SERVICE LETTER

SUBJECT: HONEYWELL SERVICE BULLETIN KRA 405B-13

Service Bulletin

BULLETIN NO: KRA 405B-13
KRA 405B Radar Altimeter

Figure 1
New Outer Cover

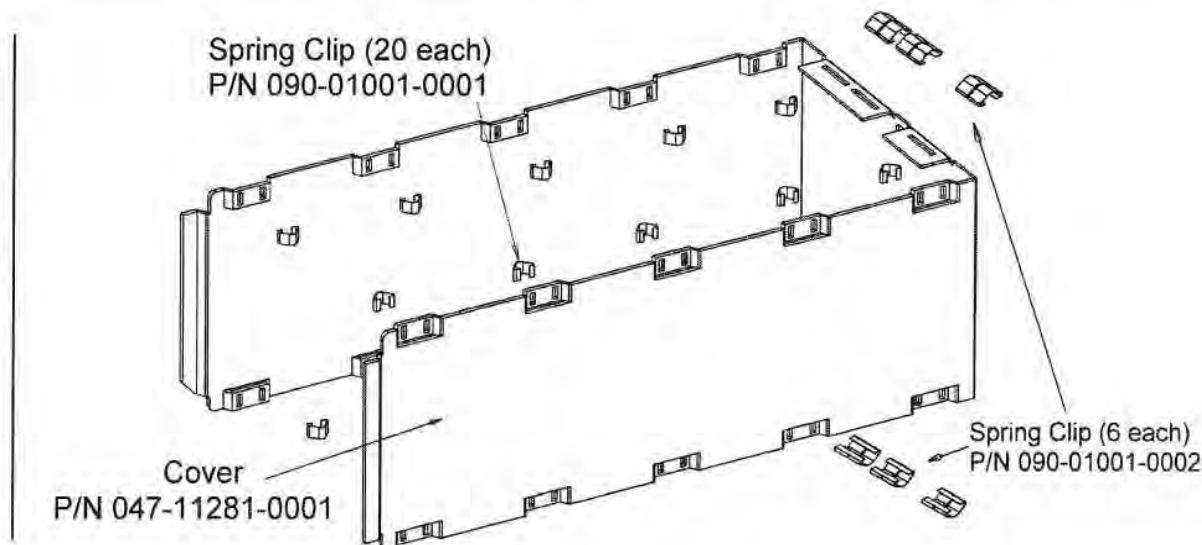
- C. Install a new U10.
6. Attach a piece of magwire connecting output tab of U13 pin 4 to U10 pin 4. Route the magwire exactly as shown in Figure 2.
7. See Figure 1 as needed. Inspect the unit cover to determine whether it is the new Cover P/N 047-11281-0001 or the old Cover P/N 047-11016-0001. (Some newer units might already have the new cover installed.) The new cover has 5 locations on each side edge for 1 spring clip each, for a total of 20 spring clips on the sides. The old cover has 4 locations on each side edge for 2 spring clips each, for a total of 32 spring clips on the sides. Both covers have 6 spring clips on the back.
If the unit has the old cover, remove the 6 spring clips P/N 090-01001-0002 from the back of the cover. Install them on the new cover P/N 047-11281-0001. Install 20 new spring clips P/N 090-01001-0001 on the new cover. Discard the old cover.

8. Reassemble the unit according to maintenance manual procedures, installing the new Outer Cover P/N 047-11281-0001 in place of the old cover.

Figure 2
Receiver/Transmitter Board Assembly Drawing
300-09034-0010 Rev F
Enlarged Detail

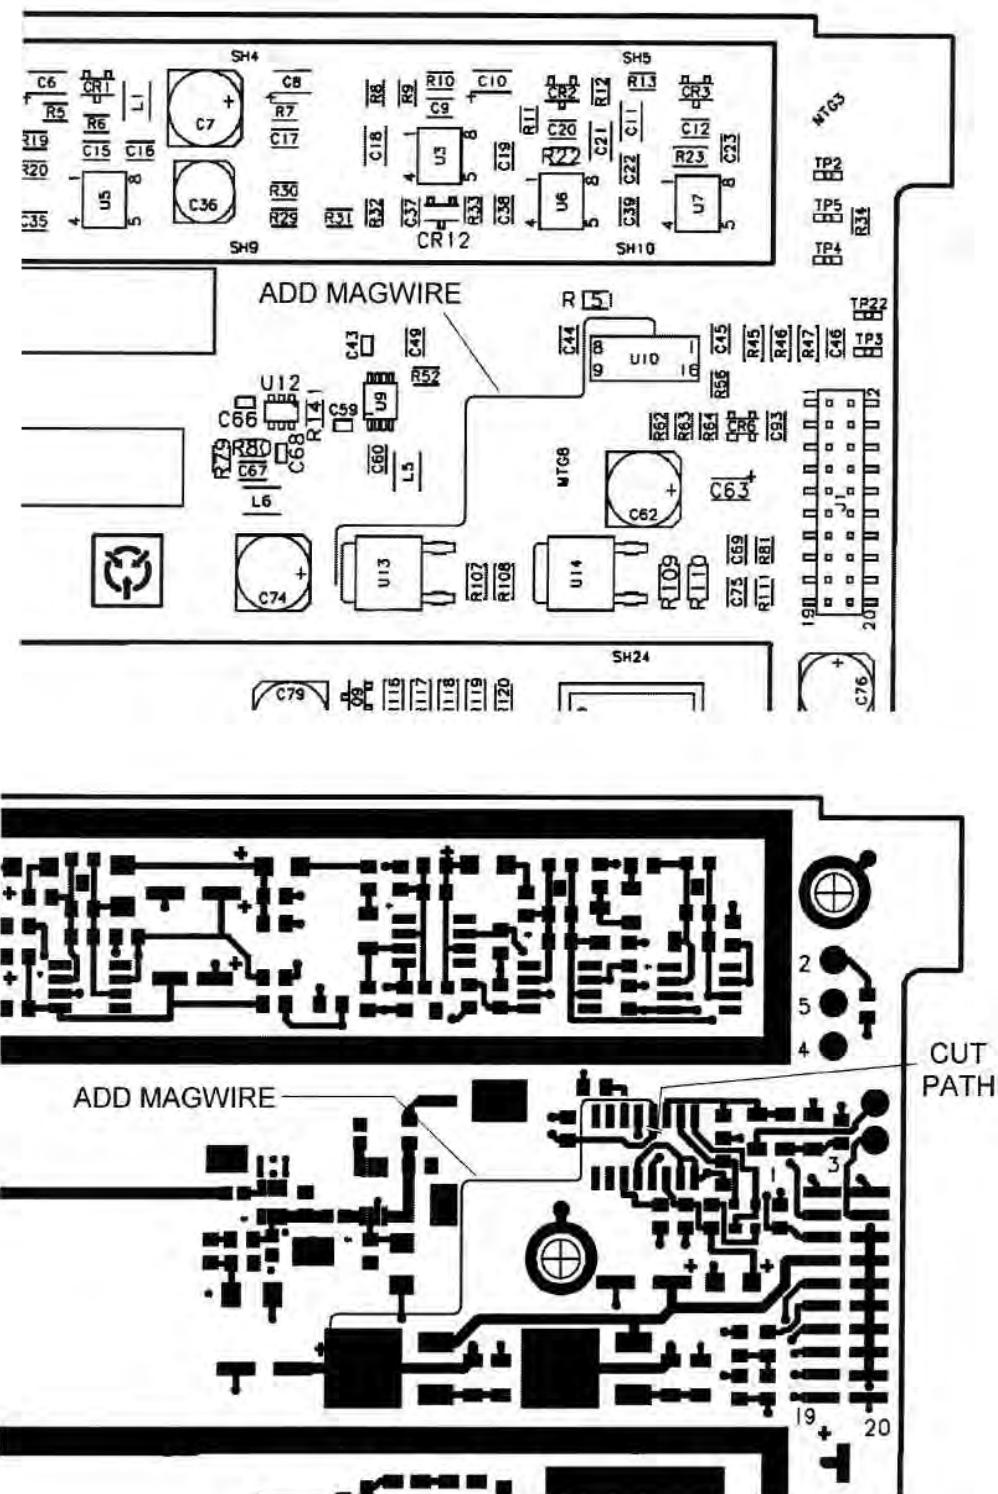
2. Replace R7 with a new R7 P/N 139-03010-0010.
3. Replace C17 with a new C17 P/N 106-05153-0046.
4. Replace R64 with a new R64 P/N 139-02672-0010.
5. Cut the circuit path as shown in Figure 2.

- A. Remove U10.
 - B. Cut the trace to the pad of U10 pin 4. This cut must be made at the inside edge of the pad, separating it at the pad from the path connecting it.
